Office Action Summary	Application No. 10/796,056	Applicant(s) KANBE ET AL.	
	Examiner William P. Fletcher III	Art Unit 1792

DETAILED ACTION

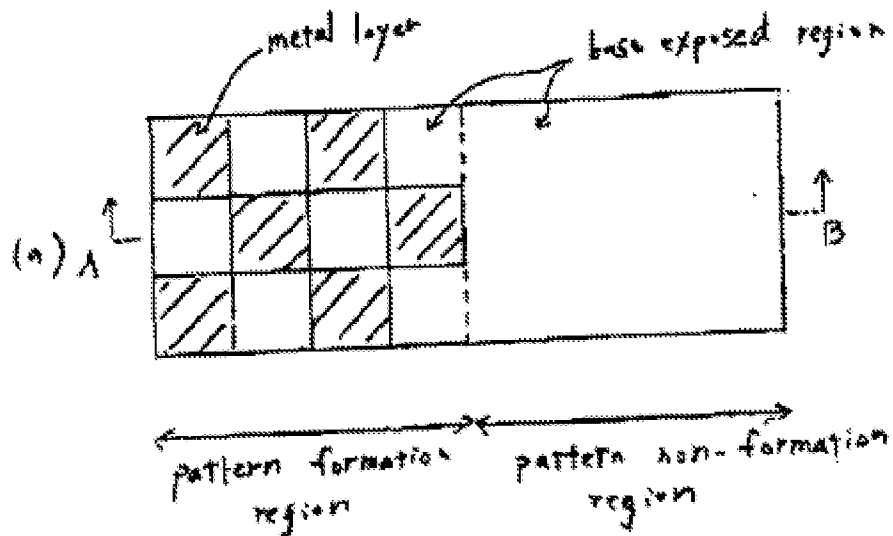
10. Claims 3 and 19 recite the limitation: "...to form a pattern non-formation region comprised of a metal layer pattern non-formed region and a pattern formation region comprised of a metal layer pattern formed region and a base exposed region." Applicant has illustrated this limitation as follows:

The Examiner has reviewed the portions of the specification that Applicant asserts as supporting this limitation, but none appear to describe illustrated arrangement including the “pattern non-formation region” of exposed base (at right in the illustration). The specification only describes the illustrated alternating areas of metal and exposed base (at left in the illustration). Consequently, the newly added subject matter is not fully supported by the originally-filed disclosure.
